DEVELOPMENT APPLICATION ASSESSMENT REPORT

| Application Number: | DA2019/1403 |

| Proposed Development: | Alterations and additions to the first floor accommodation, new doors to North Steyne, replacement awning to the Corso, signage zones, air-conditioning to the roof and other ancillary works at Hotel Steyne to Hotel Steyne |

Proposed doors in the eastern elevation.

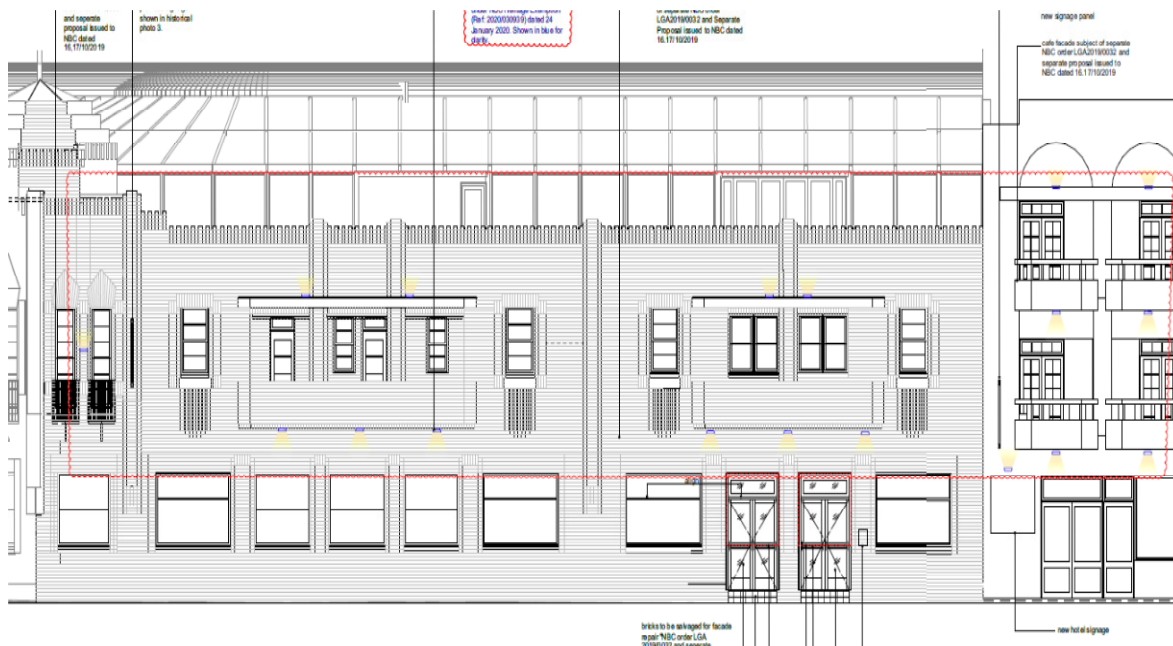
The external alterations to create a new doorway opening on North Steyne is consistent with the design principles and details in that the scale, proportions and pattern of openings are consistent with the existing facade.

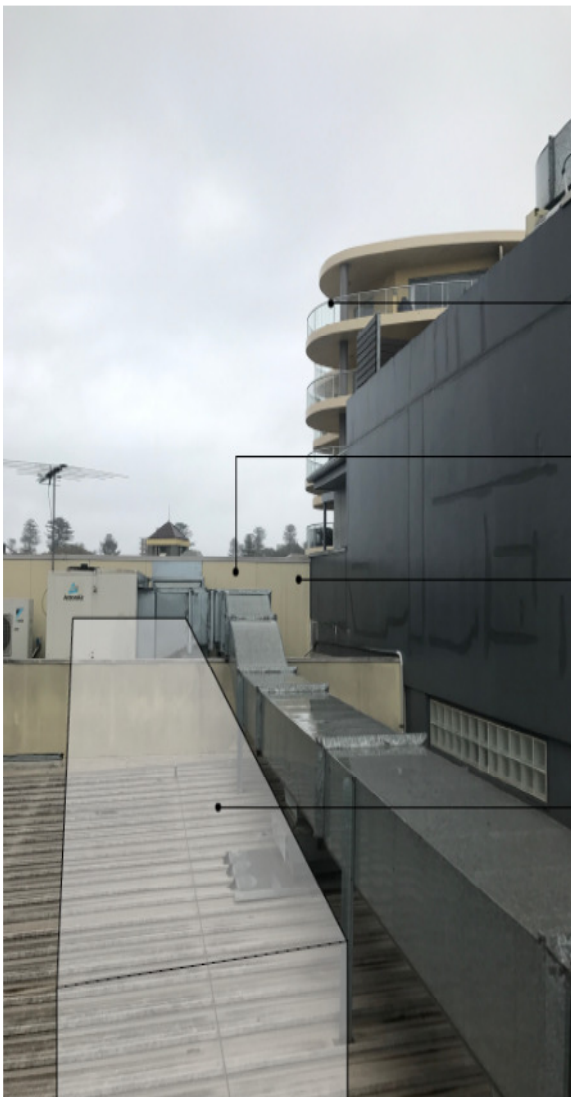
As discussed above, the air conditioning units are sited below the height of the western parapet.

Subject to a condition requiring the siting of Unit A to be directly adjacent to the western parapet wall it is unlikely that the unit will be visible from the the upper floor apartments of the Waves development looking east towards the foreshore, as such it has been assessed that the unit will not result in loss of views and the siting of the unit complies with objectives of clause 3.4.3.
